Mayberry, Colorado Springs

Filing No. 3

Construction Drawings

MAYBERRY, COLORADO SPRINGS - FILING NO. 3

TYPICAL MINOR COLLECTOR ROAD SECTION
 SCALE: 1"=5' H
 1"=2.5' V

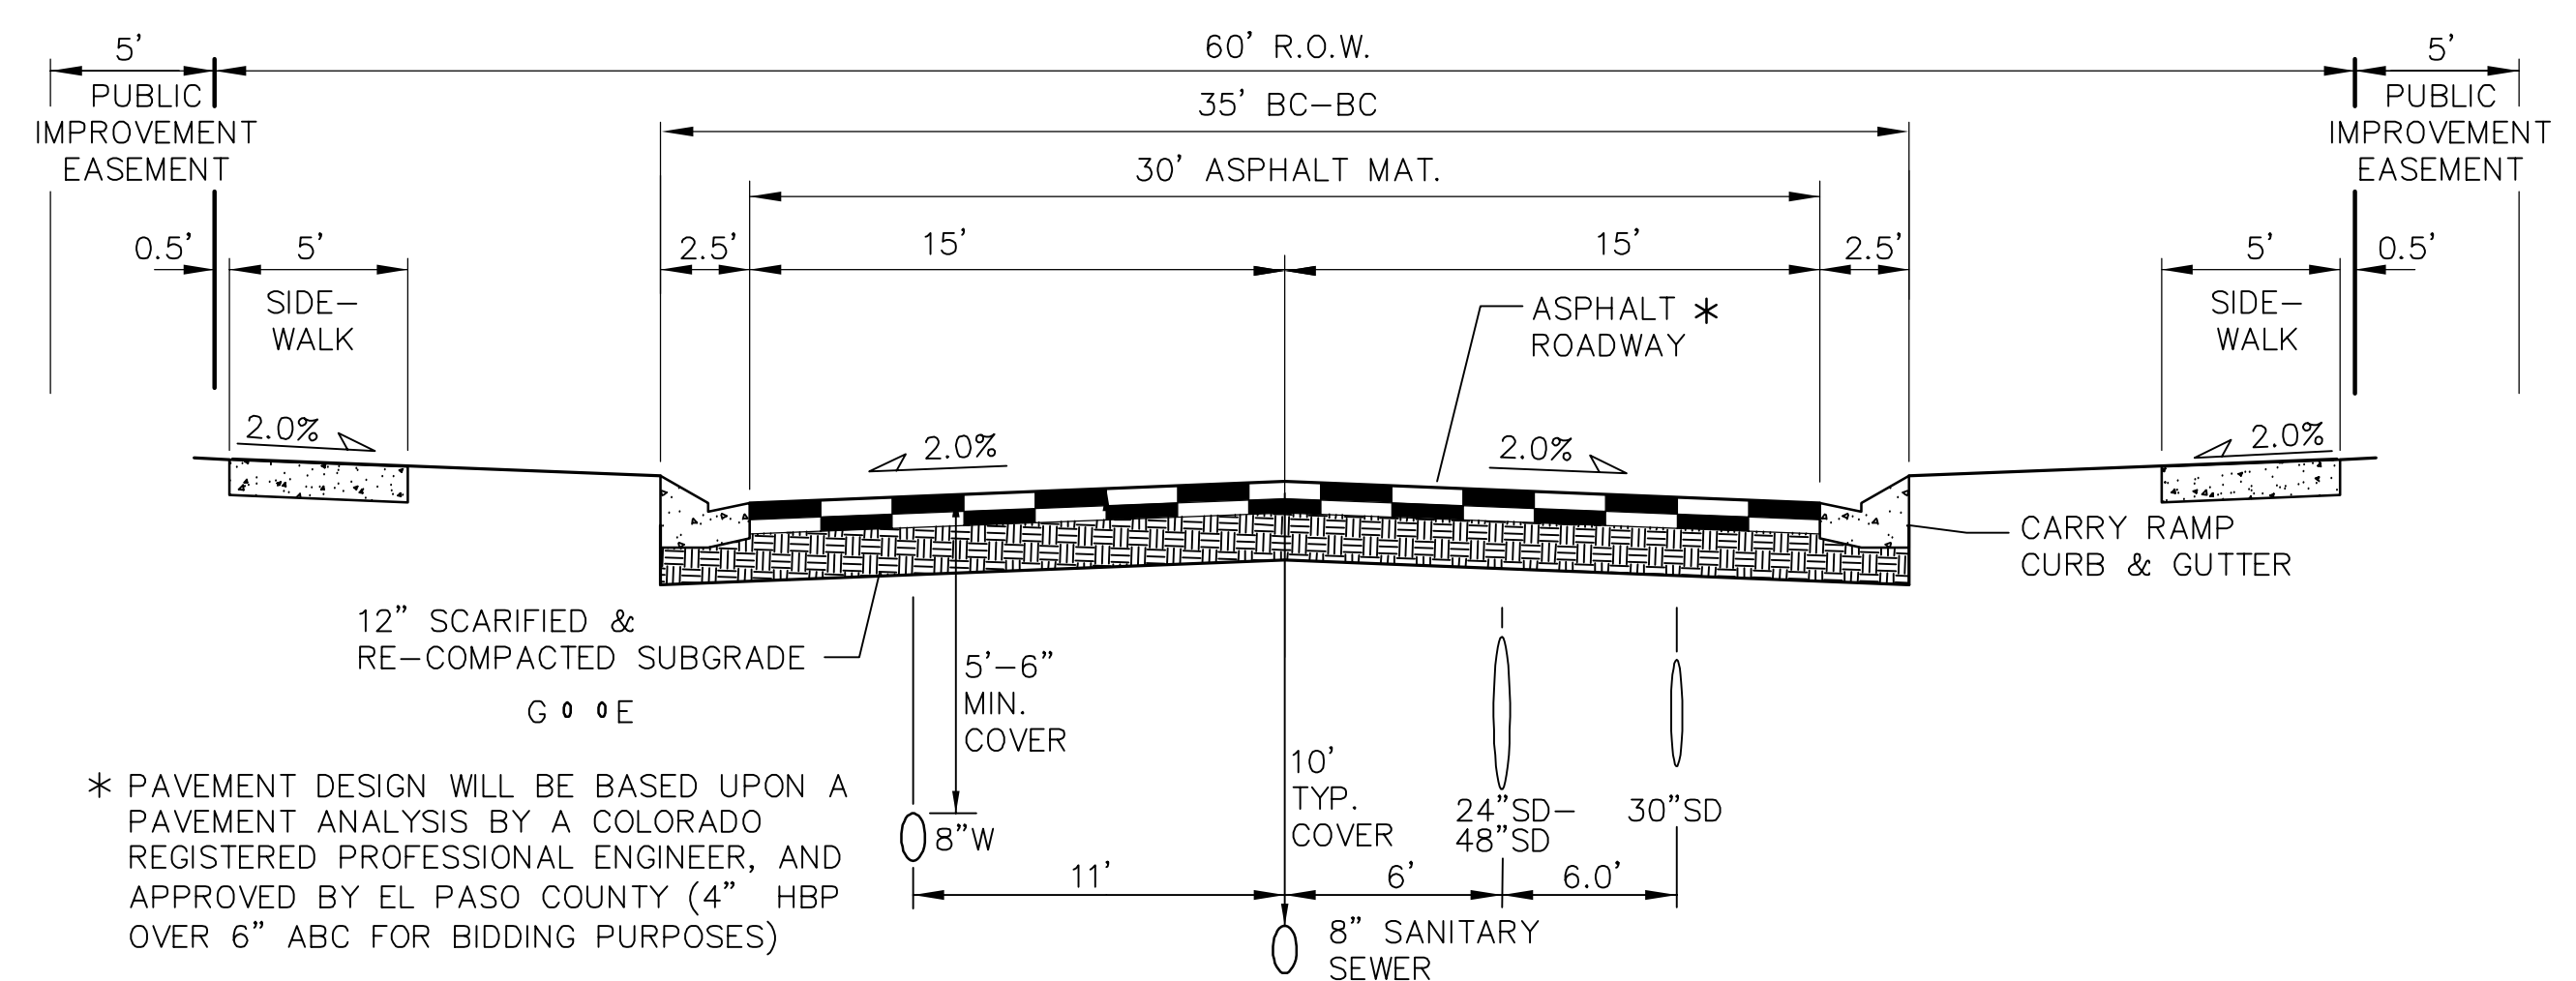
Call out the curb and gutter type that will be used in the cross sections.

TYPICAL LOCAL ROAD CURB RADIUS DETAIL (B) SCALE: NTS

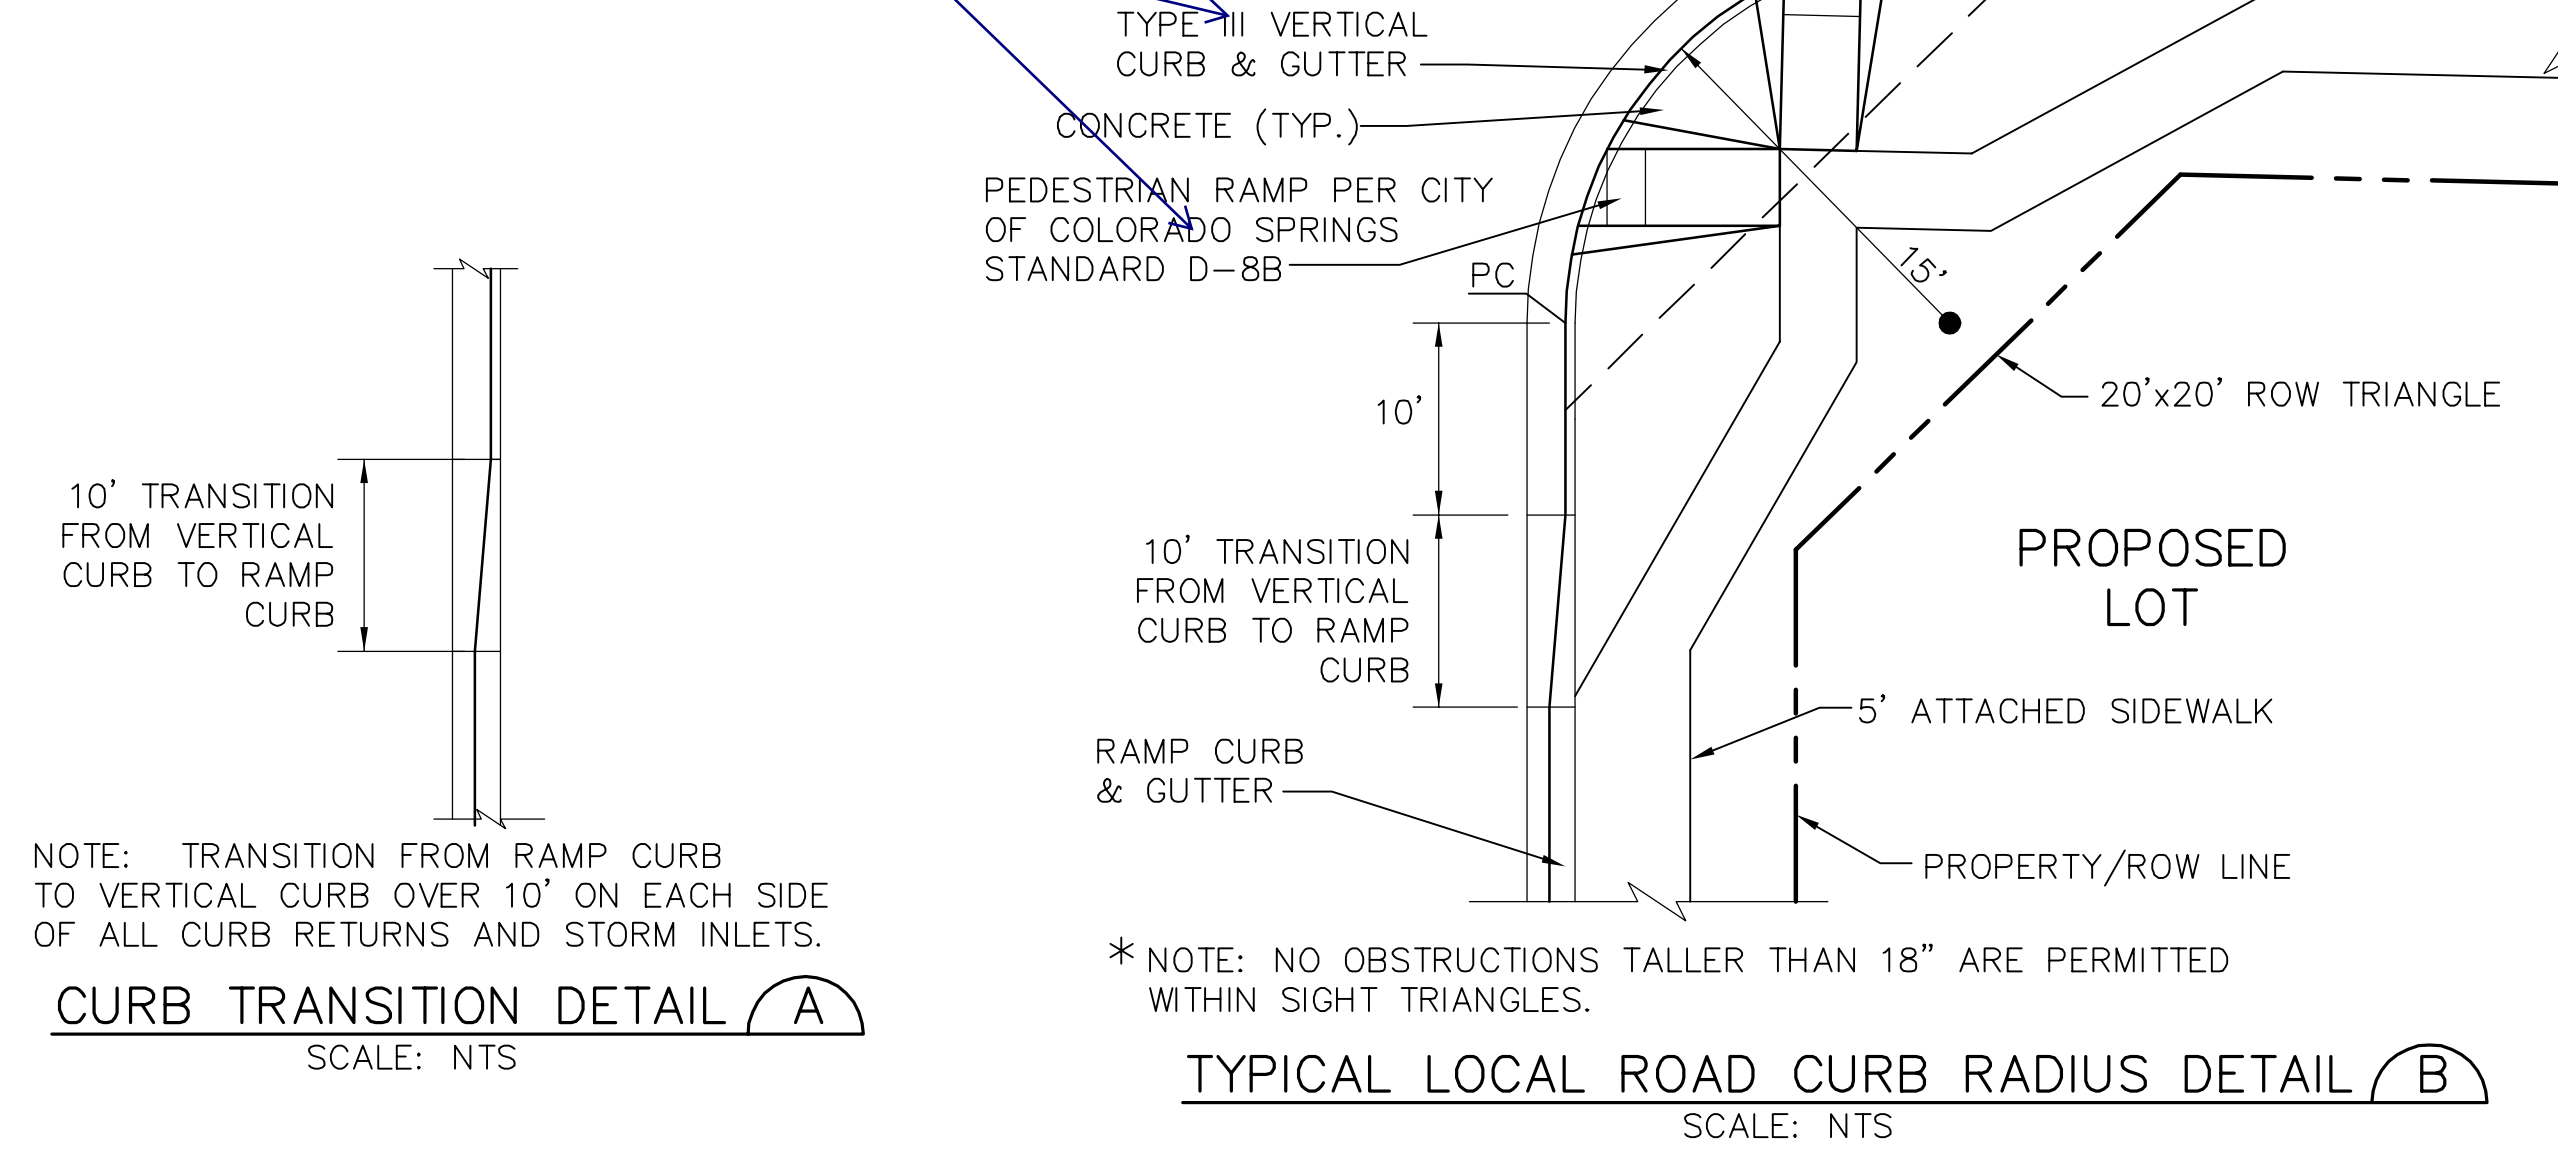
identify County PED ramp detail and curb/gutter type

include parallel ramp detail SD2-50
